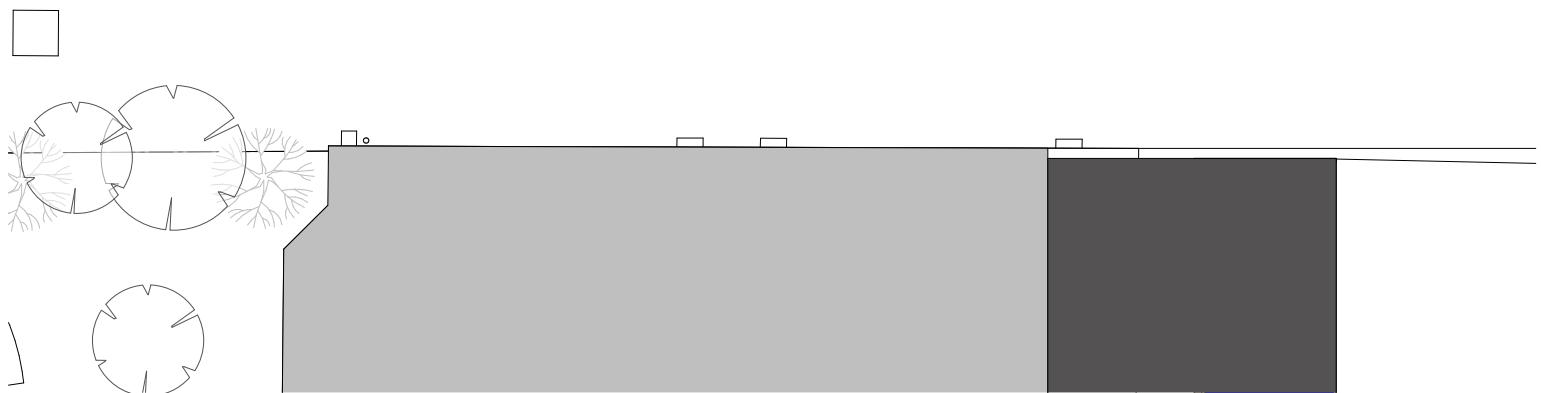
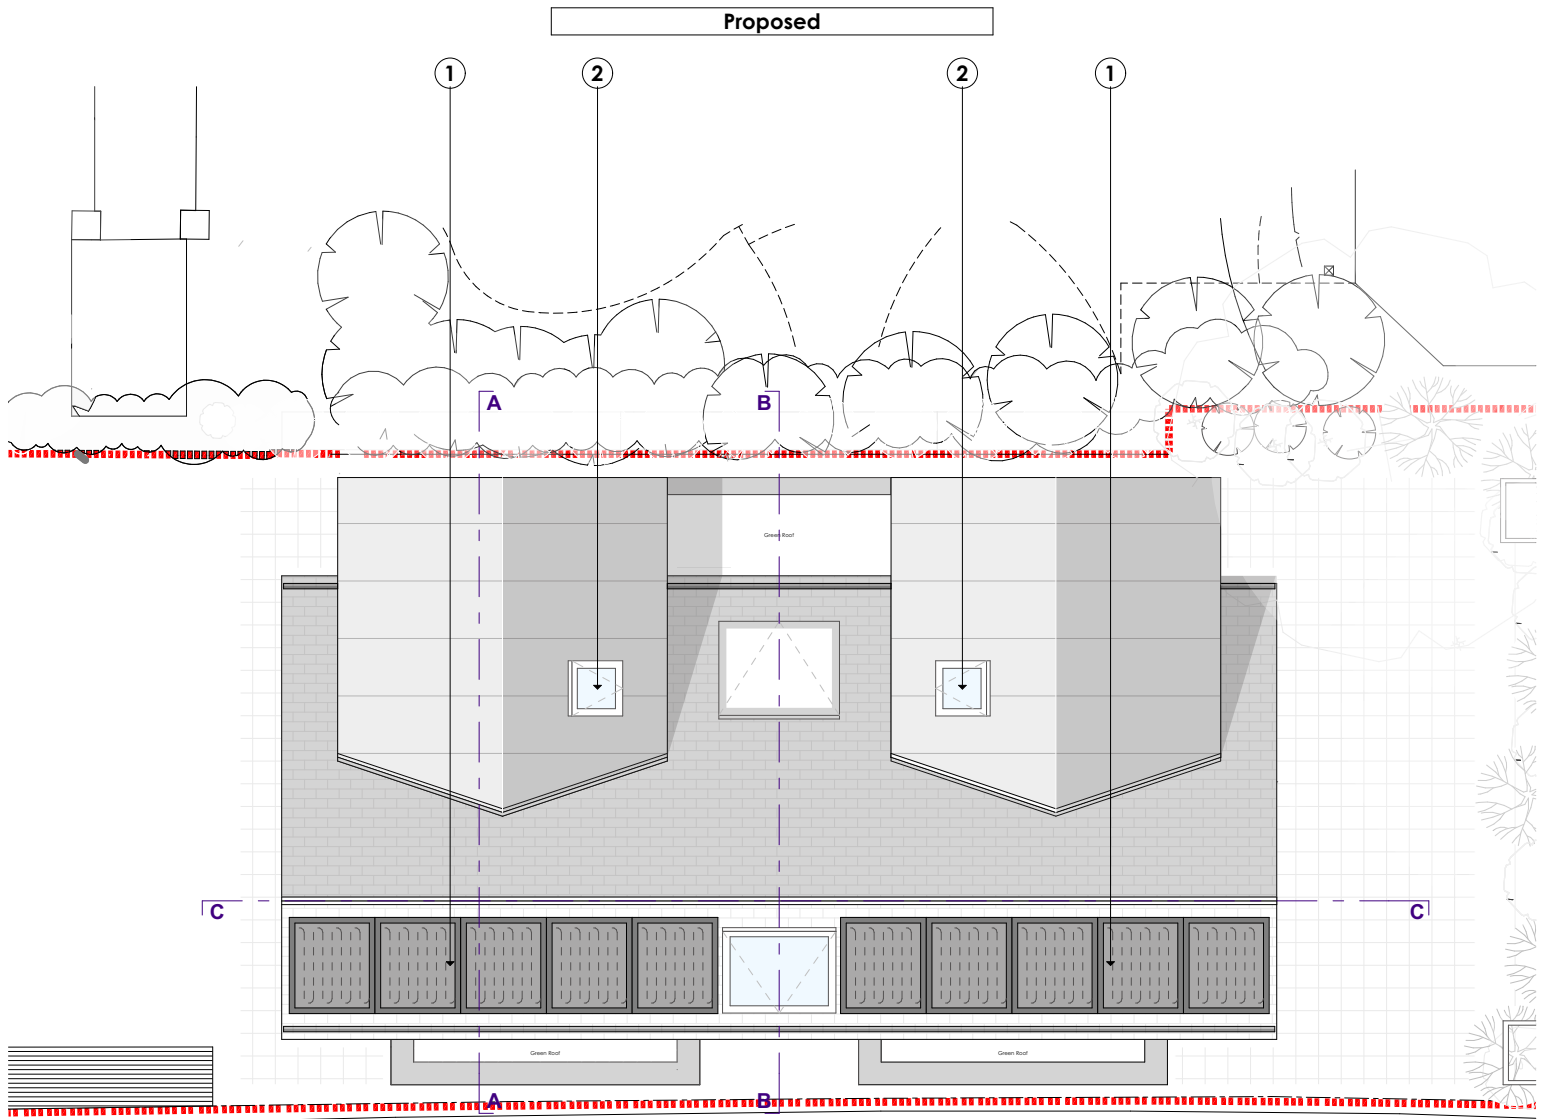
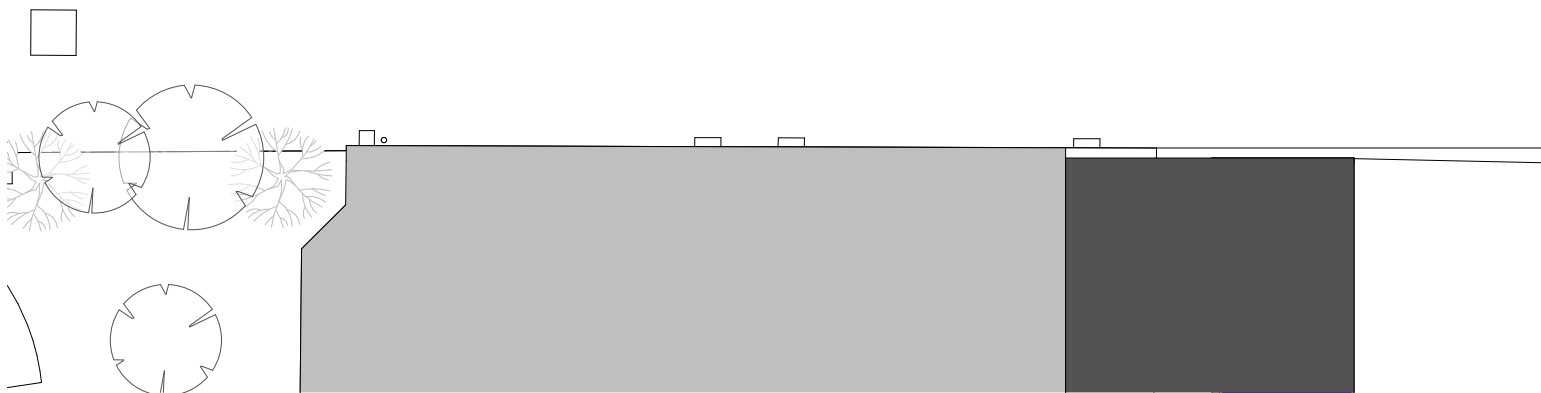
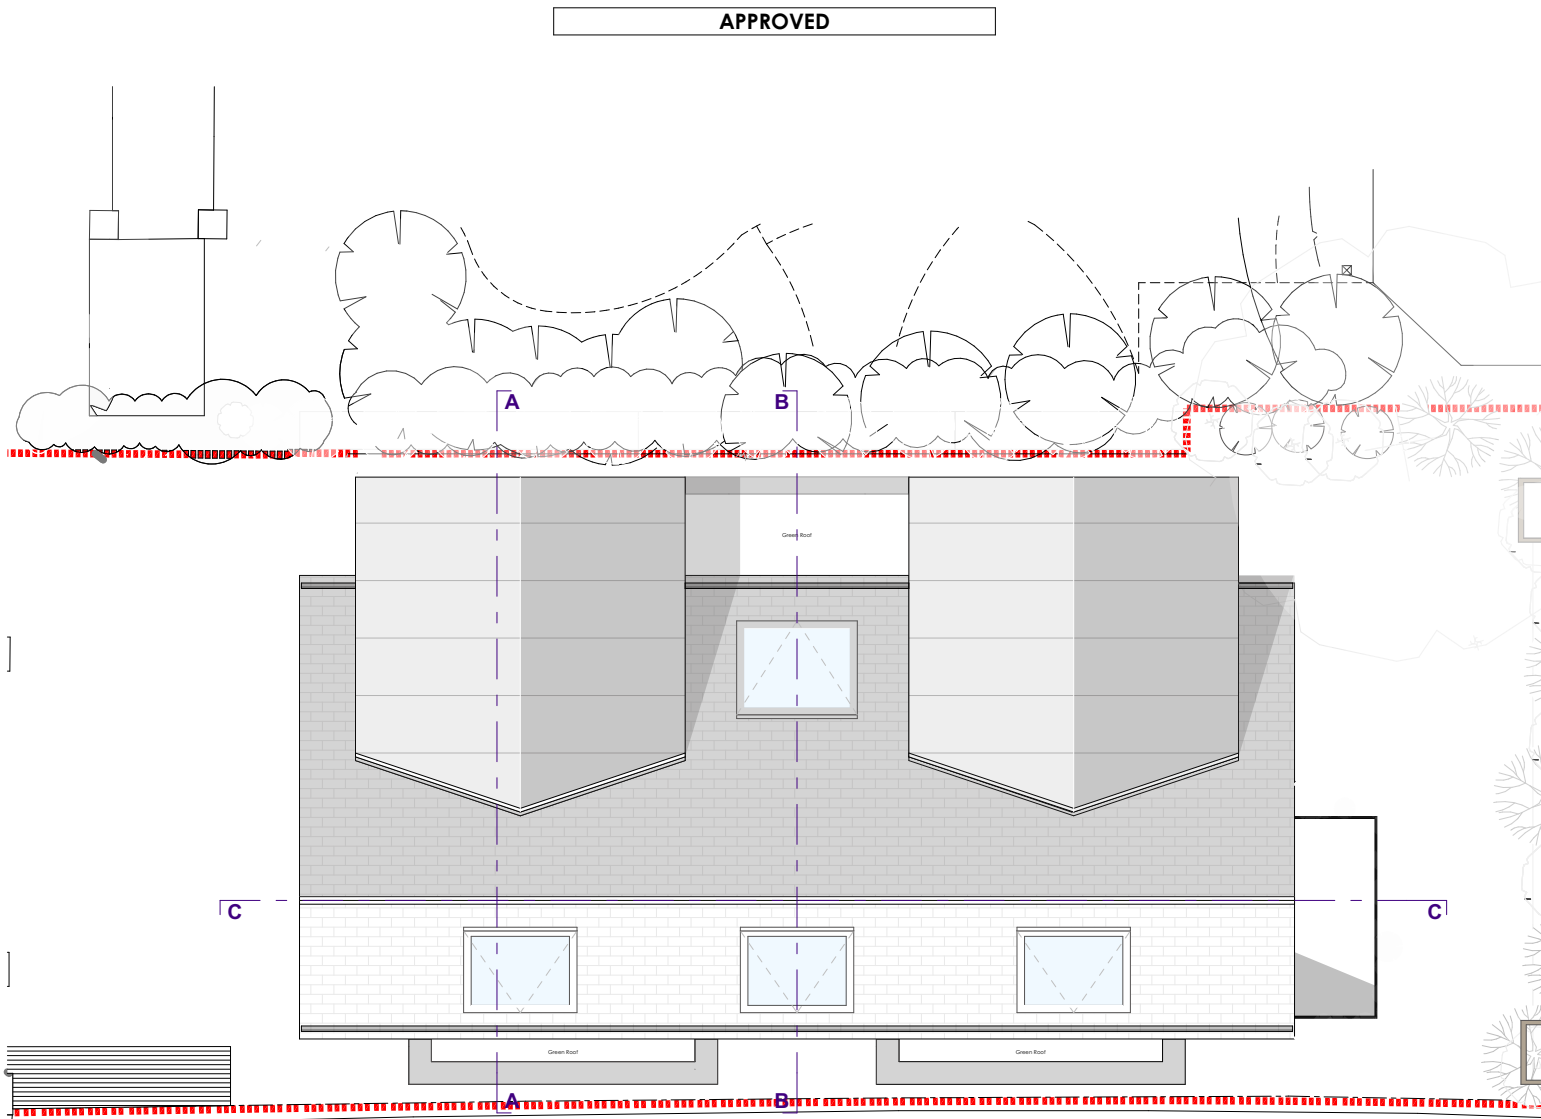
Internal alterations include new study at top of stairs

Changes:

(1) Approved bedroom skylights removed to accommodate 10x PV panels

(2) New skylights installed on inner pitch(es) of dormers. Positioning on inner faces mean that alterations will be invisible from front elevation.

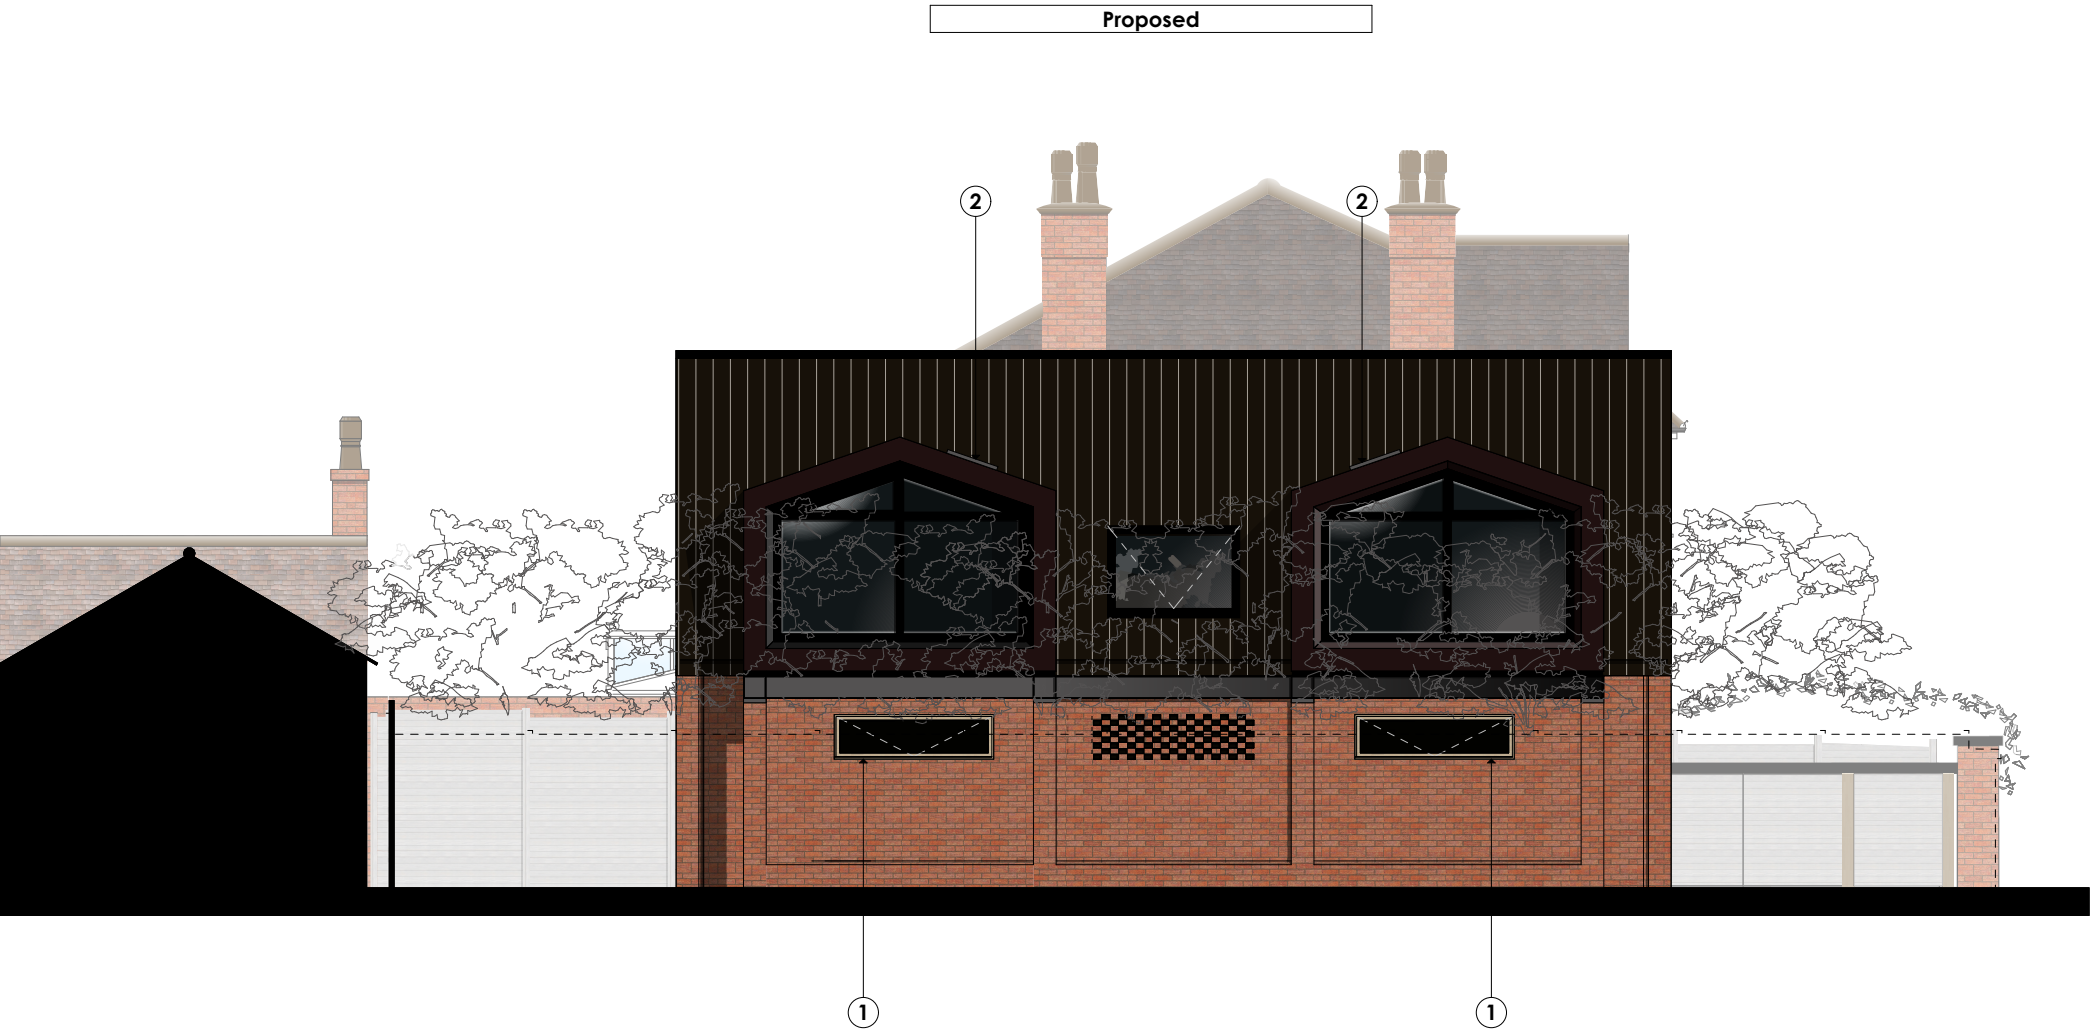
Changes:

- (1) Ground floor front elevation brought forwards within overhang 450mm. Protrusion of overhang unchanged.
- (2) Covered walkways at ground floor enclosed forming new entrance hallway at front of property, enlarged kitchen dining through relocated utility at rear of property. High level glazing on north elevation.

Note: Changes cannot be observed on front elevation drawing.

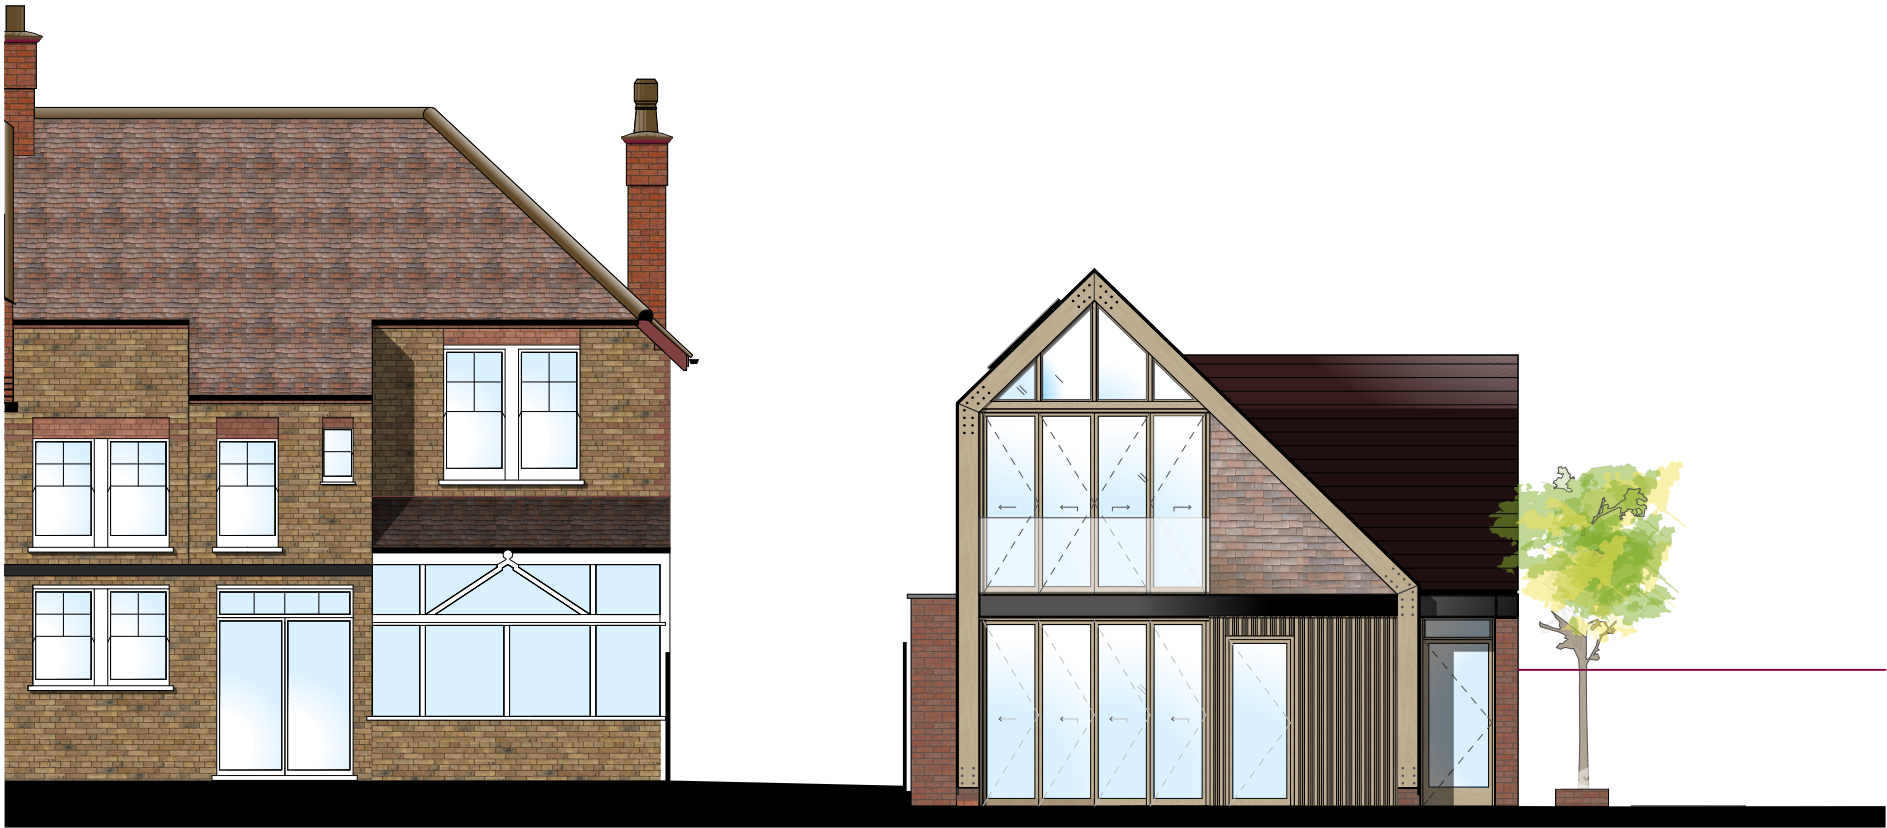
Changes:

(1) Covered walkways at ground floor enclosed forming new entrance hallway at front of property, enlarged kitchen dining through relocated utility at rear of property. High level glazing on north elevation, will mostly be concealed by approved boundary pleached trees.

(2) New skylights installed on inner pitch(es) of dormers. Positioning on inner faces mean that alterations will be invisible from front elevation.

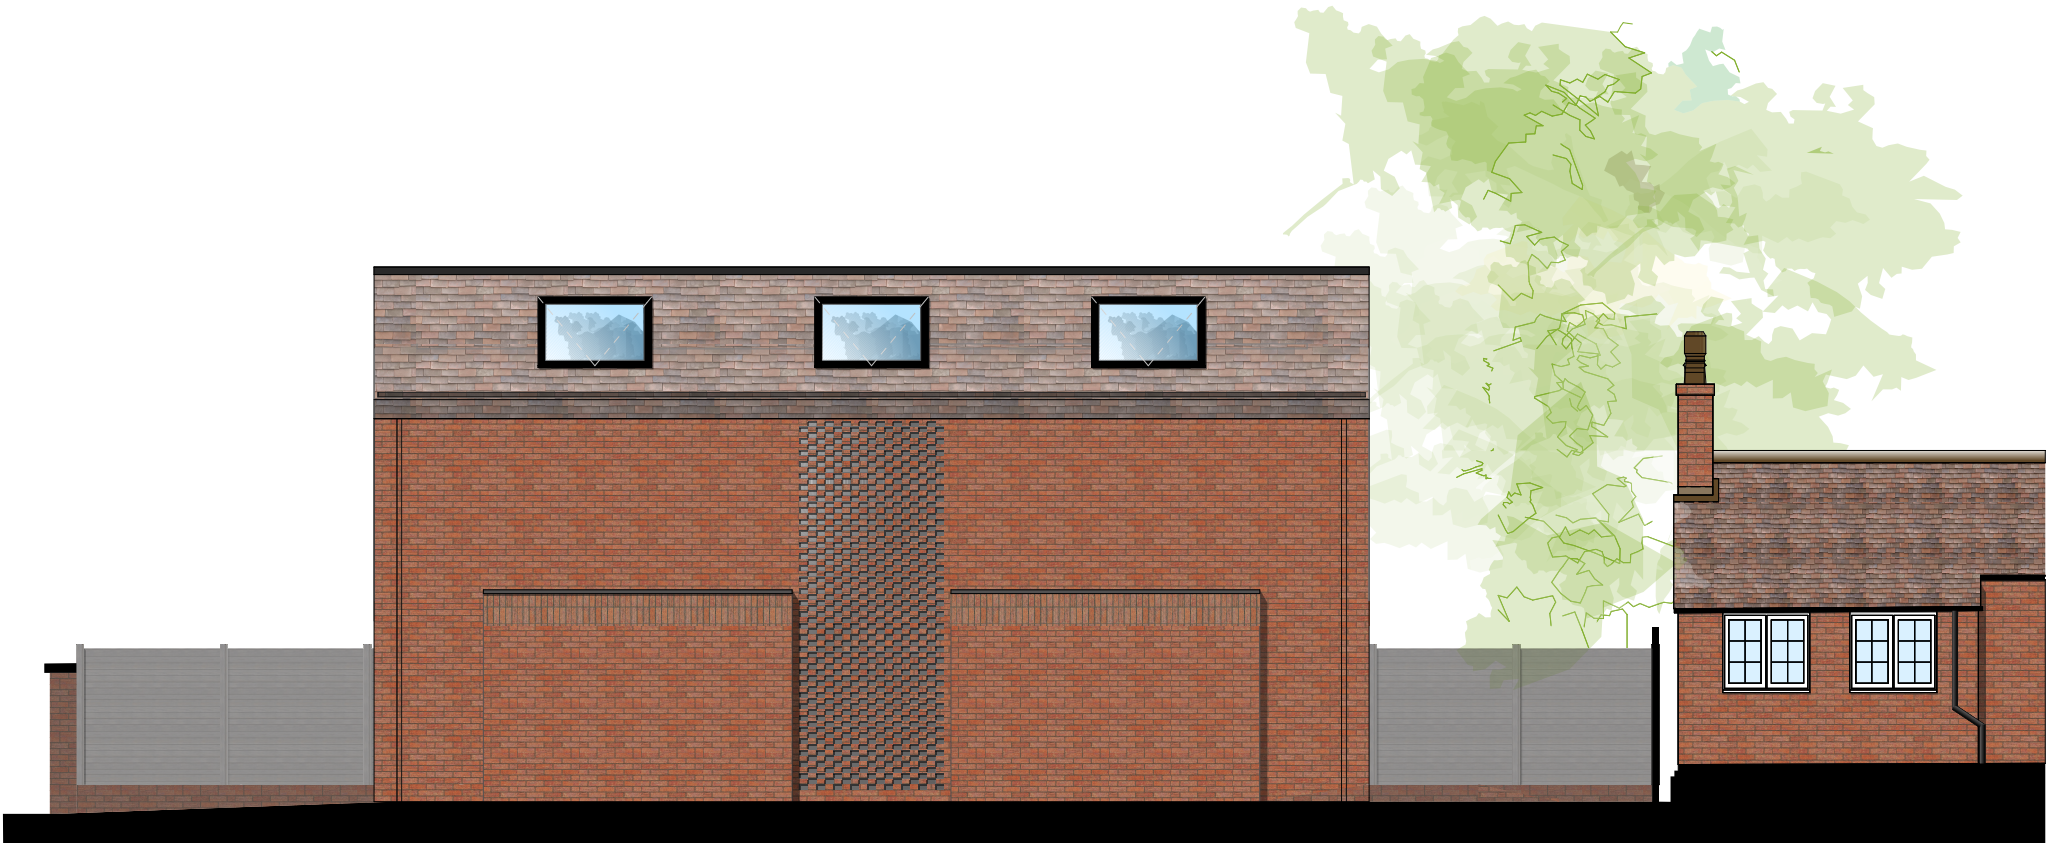
Changes:

(1) Ground floor rear elevation brought forwards within overhang 450mm. Protrusion of overhang unchanged.

(2) Covered walkway at ground floor enclosed forming enlarged kitchen dining through relocated utility at rear of property. High level glazing on north elevation.

Note: Changes cannot be observed on front elevation drawing.
